Re: Permit No. WQ0015065001

In response to Executive Director's Response to Hearing Request, the requester submits the following. Specifically, the issue concerning the petitioner for this hearing is not a water quality issue but a water quantity, water rights, issue. Specifically, the right of the down stream property owner not to be inundated by alteration of natural drainage. This issue is appropriately directed to your office after reference by USDA NRCS(NRCS), successor to US SCS, and Texas State Soil and Water Conservation Board(TSSWCB).

1) Overview Between Caney Creek and Peach

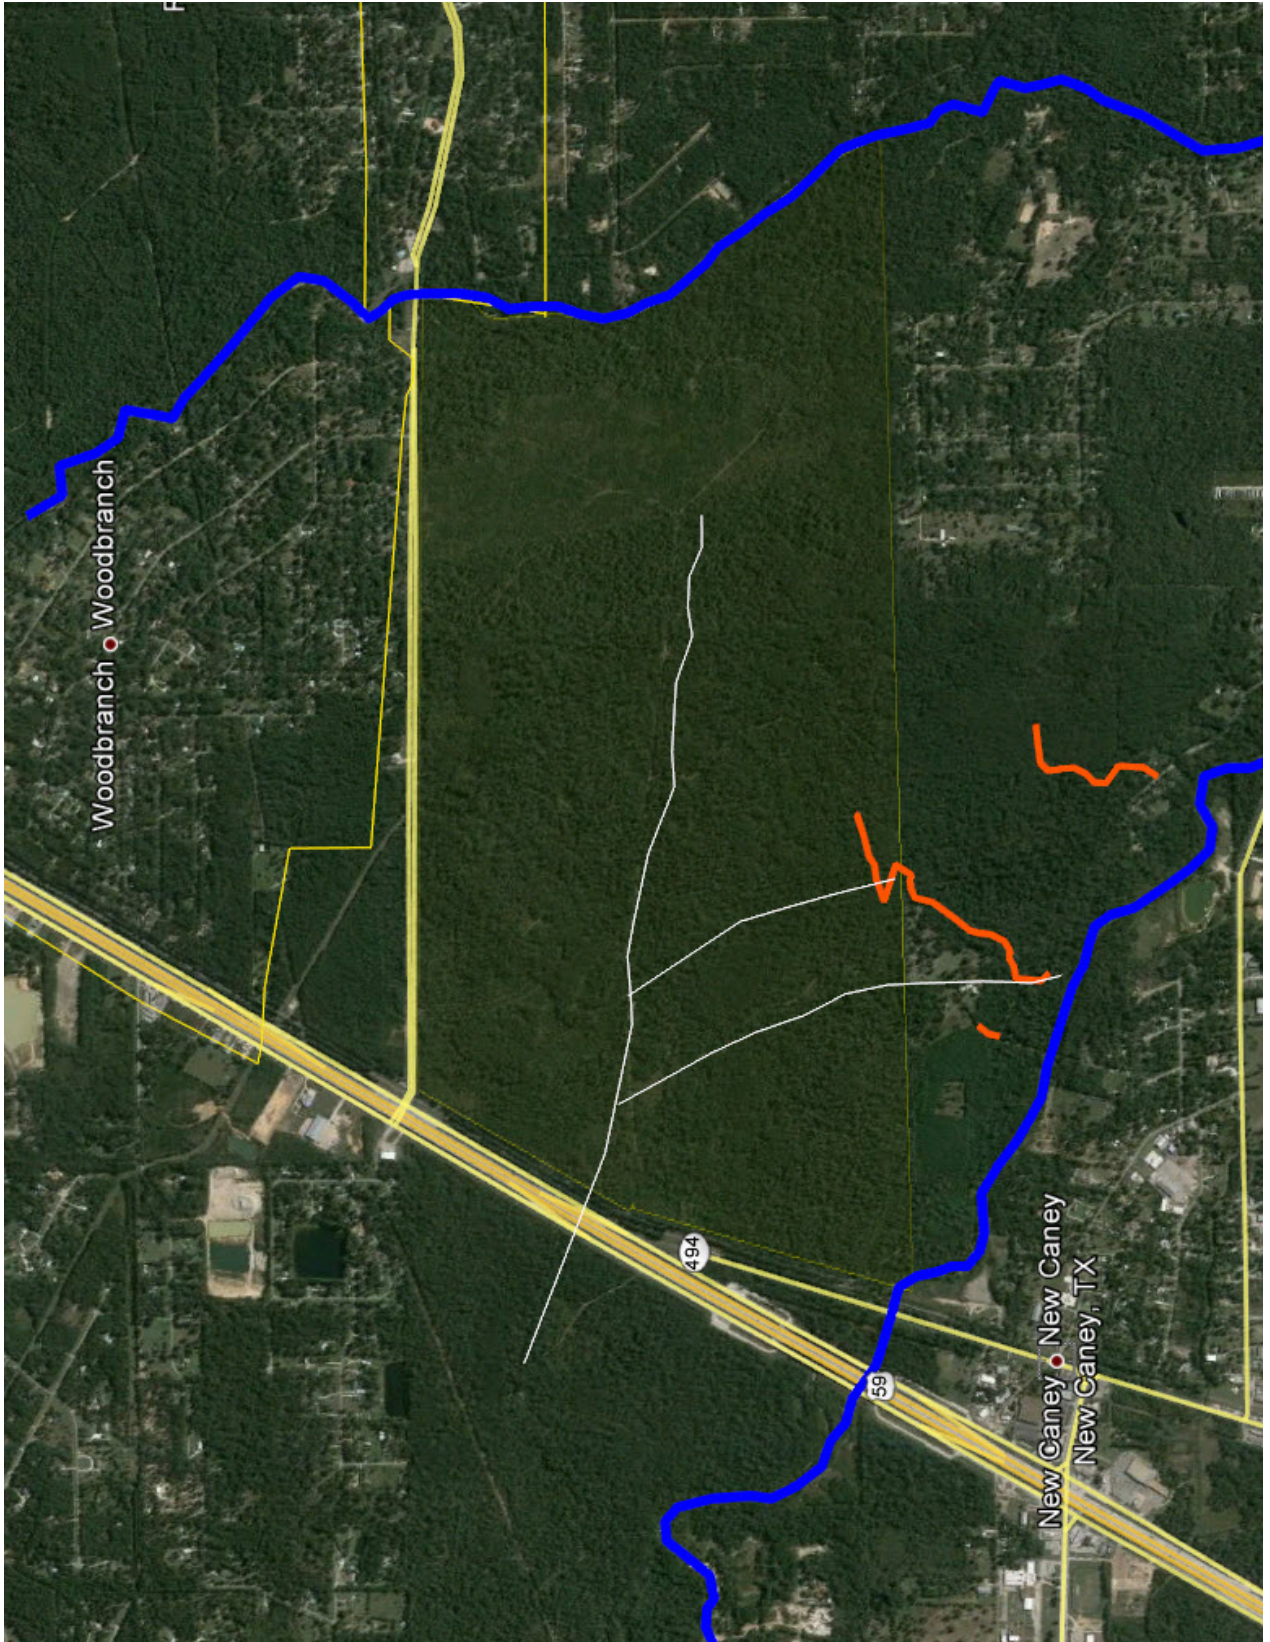
Please consider attachment 1) an overview of the proposed development site east of US Hwy 59. There are several relevant features on this image. First are the existing creeks, shown in blue. Second are the surface expressions of subterranean faults shown as white traces. These faults define local relative 'highs' and, with the exception of times of flood will be shown to control run off from the current TCEQ approved site. These local

relative 'highs' also limit drainage areas. So for instance, drainage passing under US59 from the west and south of the east west trending fault drains south to the corner of Comer Reinhart Rd. Surface drainage from North of the East West trending relative high and to the East of US 59 drains to the east and ultimately into Peach Creek. Some portion of the subsurface flow ultimately percolates to Caney Creek. To understand the soil percolation please refer to the Soil Survey of Montgomery County, TX. USDA publication. <http://soildatamart.nrcs.usda.gov/Manuscripts/TX339/0/Montgomery.pdf> and <http://soildatamart.nrcs.usda.gov/Manuscripts/TX339/0/Maps/Index.pdf> sheets 68 and 78.

This image also includes orange features that are eroded clay benches that were contained in laminated fine sand deposits. The local dip of these benches, most probably resulting from the faulting, is to the Southeast..

2) Overview Cross Section Grid

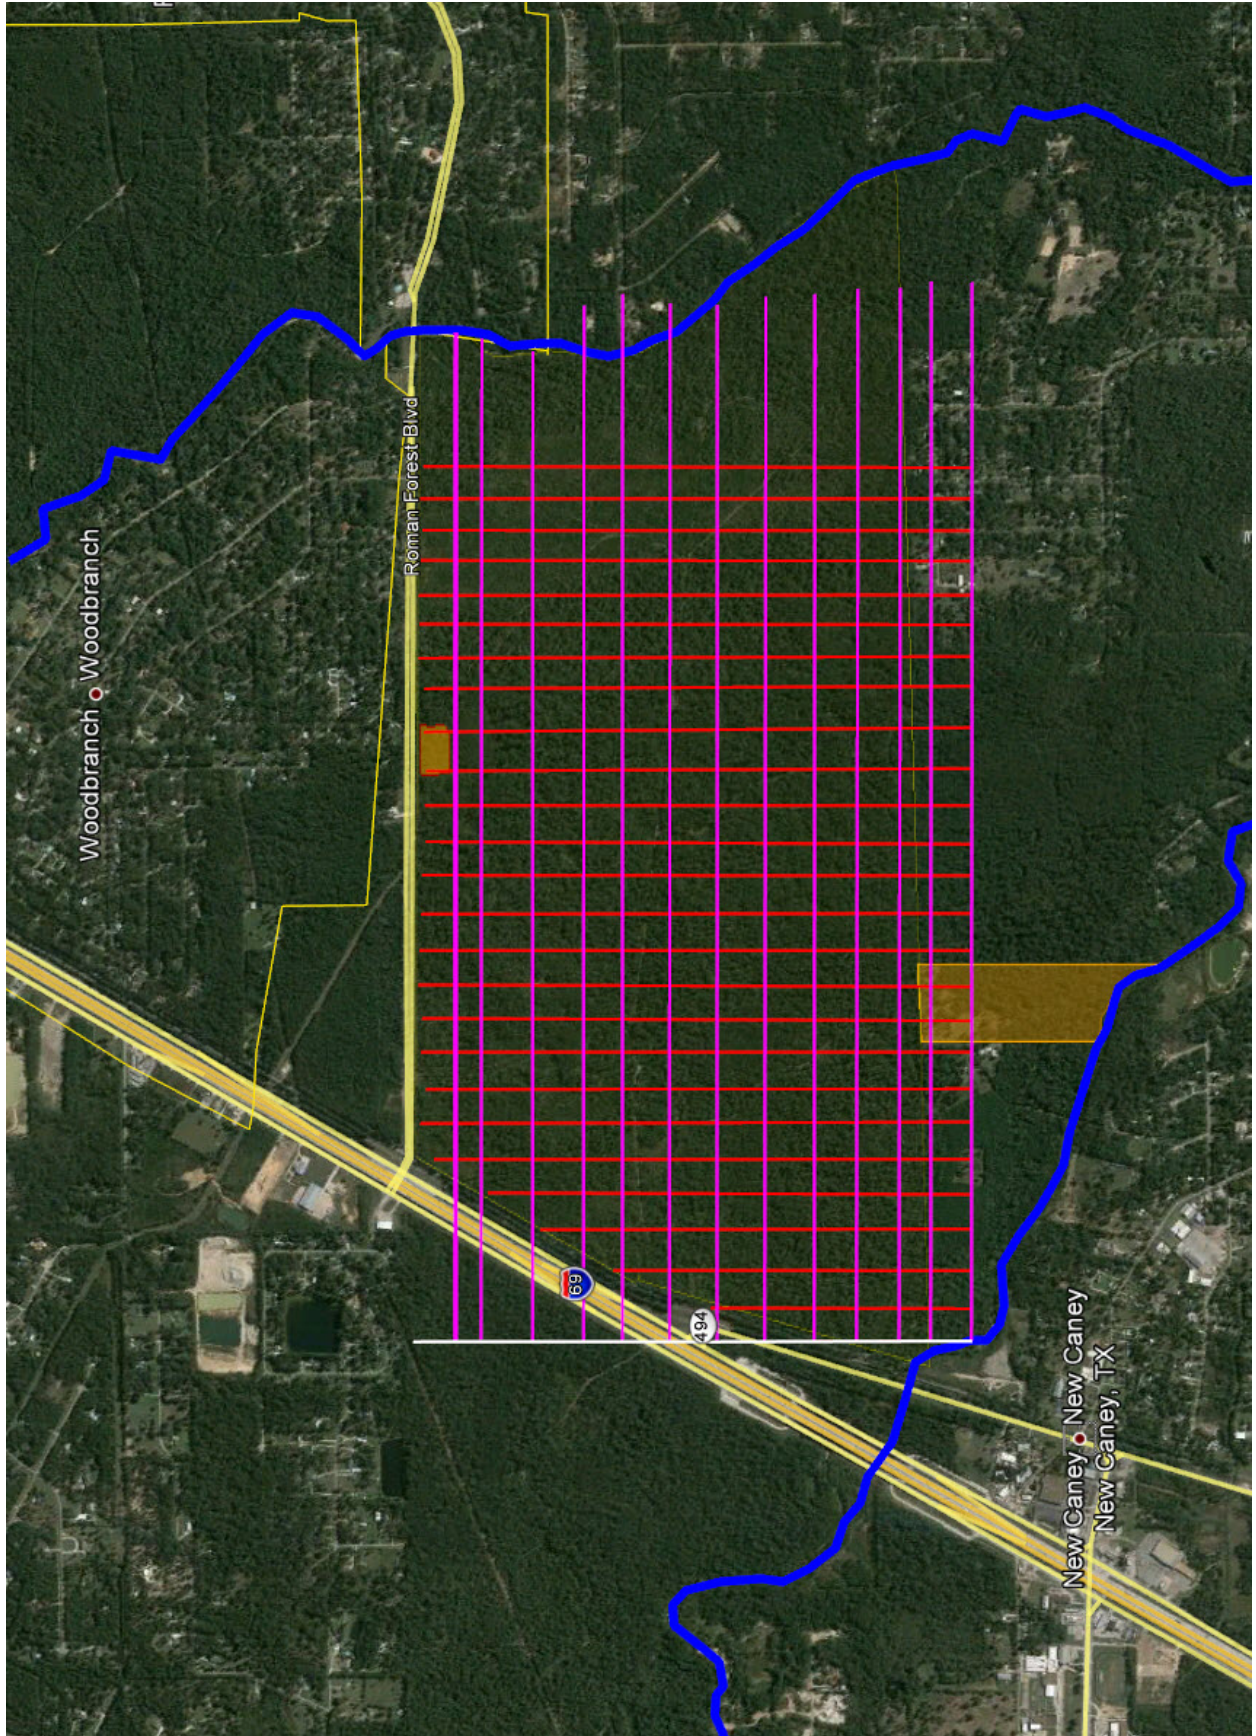
Attachment 2) represents an arbitrary cross sectional grid based on SRTM geospatial data. The horizontal sample accuracy of the base grid is +/- 45m and relative vertical accuracy projected to a given indicated line should be greater than 0.5m given that each degree of the great circle constitutes approximately 58 miles . This is sufficient to identify drainage paths. This attachment also shows the locations of the TCEQ permitted site and the F.J Foulks property.

3) Roman Forest Blvd – Parallels South of Site

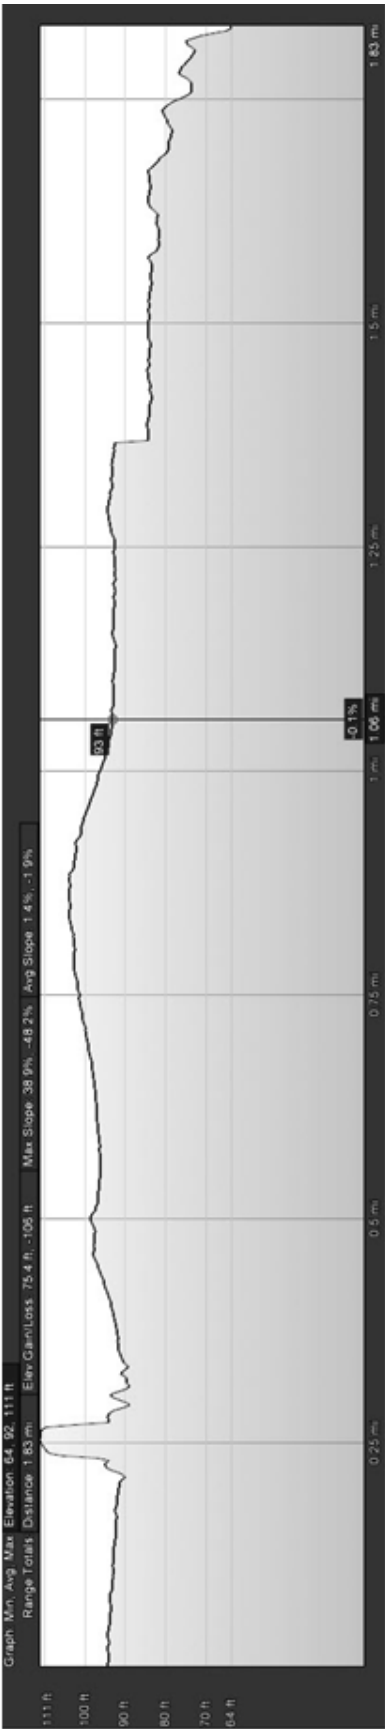
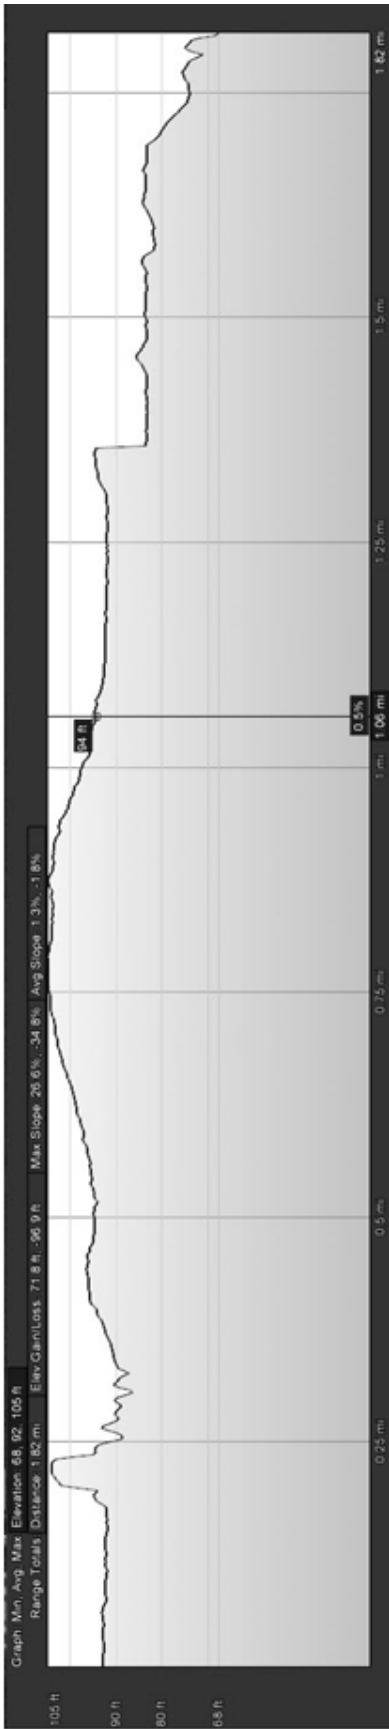
Attachment 3) shows the two West to East cross sections South of the TCEQ approved site. Notice the elevation increase to the West (left) immediately adjacent to the site.

4a) West of Site

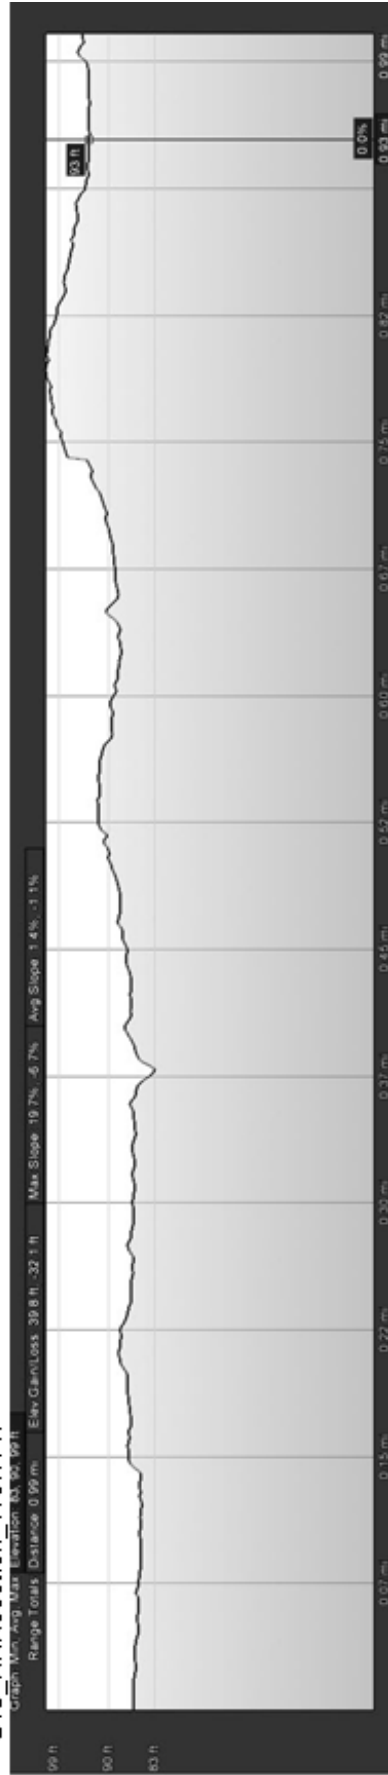
Attachment 4a) and 4b) show the South to North cross sections through the site and to both the east and west. Notice the increase in elevation to the west of the TCEQ approved site.

5) Chosen Sections

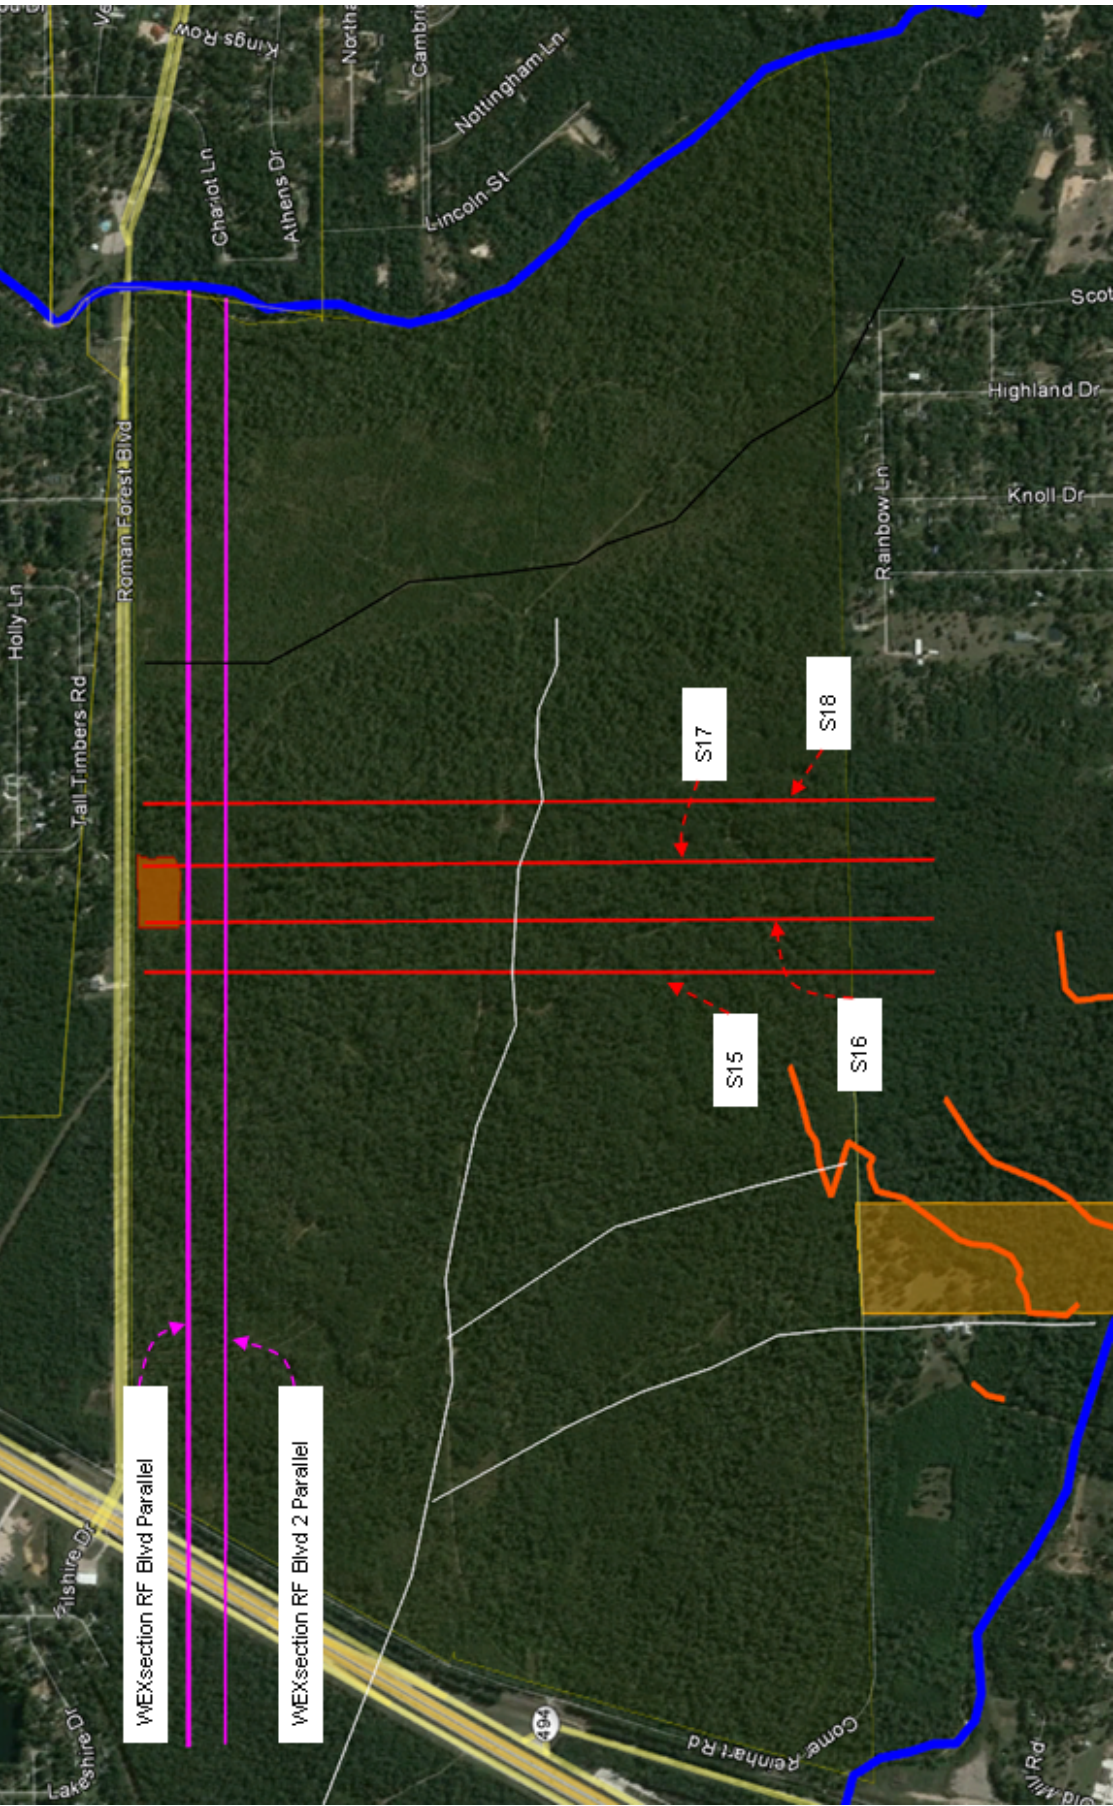
Attachment 5) illustrates the positions of the cross sections of Attachments 4a) & 4b). This image also illustrates the proximity of the TCEQ approved site to the estimated flood plane of Peach Creek.(the black line)

7) Mid property section

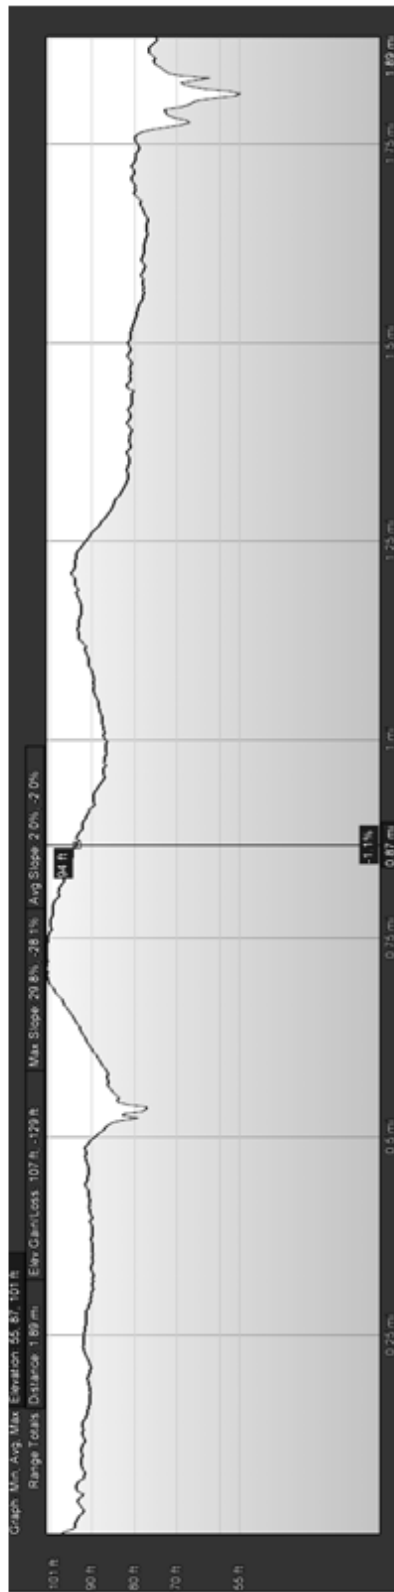
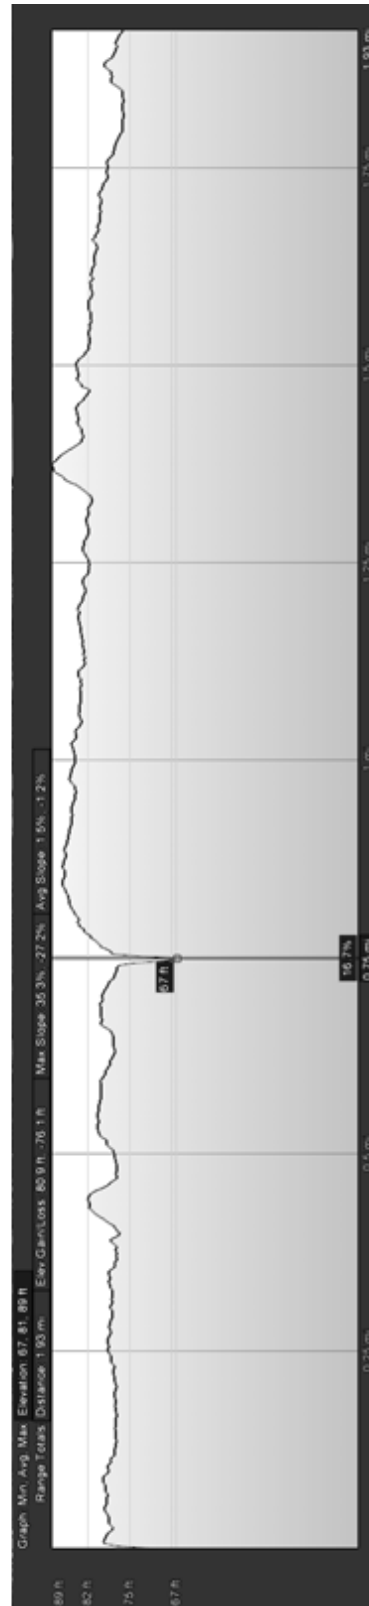
Attachment 6) is a mid property West to East cross-section illustrating the absence of "Pumpkin Gully" and the presence of other erosive features to the west of the drainage path proposed by Lennar Homes of Texas in their permit application.

Attachment 7) compares a Lennar Homes of Texas south boundary cross section with the mid property cross section of Attachment 6) illustrating that there is no path using natural drainage courses to route any of the proposed alternatives into "Pumpkin Gully" from the TCEQ approved site.
